Historic District Review Committee

Staff Report January 11, 2010

CAPP 2009-0019 Shyla and Steven Kennedy: New Residential Construction in the Goose Creek Historic District: MCPI 491-10-0145.

Figure 1: Aerial of the subject parcel comparing the proposed house location, setback, and orientation with surrounding properties. (Proposed house footprint not to scale.)

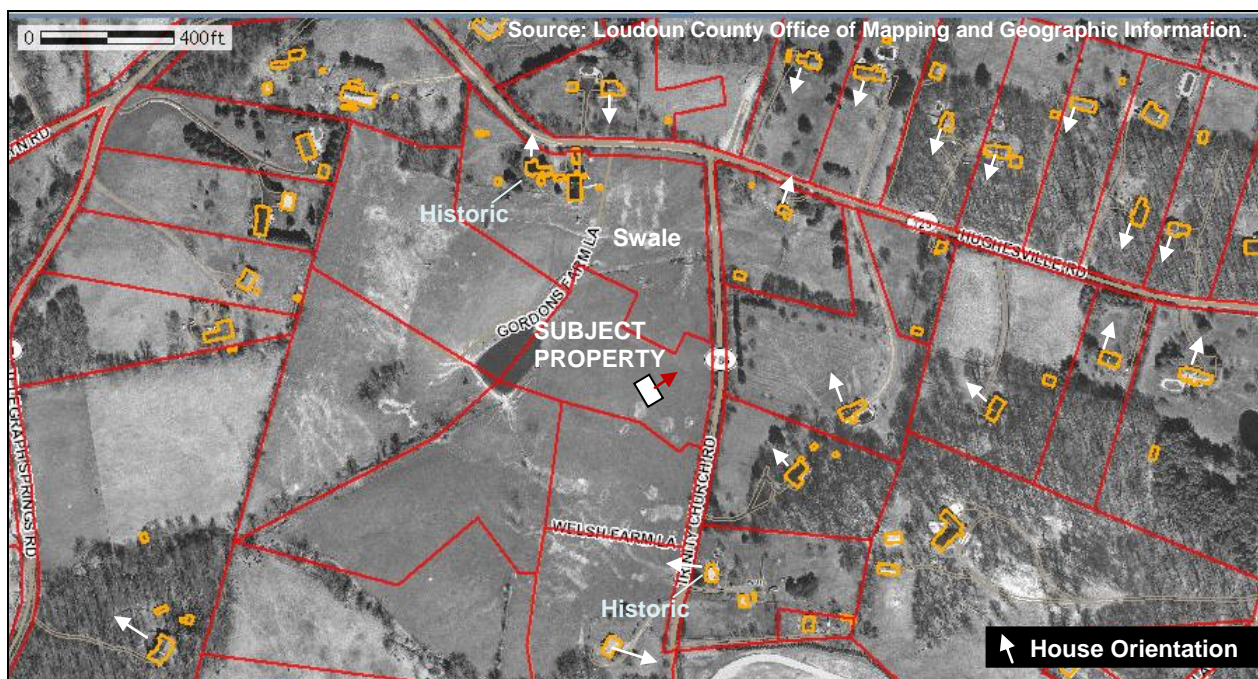
The proposed location for the house is on the flattest area on the parcel, with the side of the house setback approximately 130' from the road. This setback is greater than historic precedents of 50'-60'. However, the distance allows the proposed residence to sit lower on the property. More distance from the road may reduce the perceived mass of the building. The proposed setback is appropriate for the size and mass of the building.

The proposed orientation for the house is to the northeast, so that the rear elevation has a southwestern exposure. The applicant states in the Statement of Justification (SOJ) that this orientation is proposed to take advantage of solar gain. According to the applicant, this location will also allow the proposed residence to have an at-grade egress on the front elevation and into the garage, which is desired. This proposal results in a residence that would be oriented to Hughesville Road, nearly 700' to the north, than to Trinity Church Road.¹ Moreover, this proposed orientation does not follow any precedents; historic or modern (see Figure 1). While the location is not the highest spot on the parcel, it will be dominant on the landscape due to the lack of trees and the swale to the north. **Therefore, the proposed location for the residence does not meet the Guidelines for building placement because it is not oriented to Trinity Church Road.**
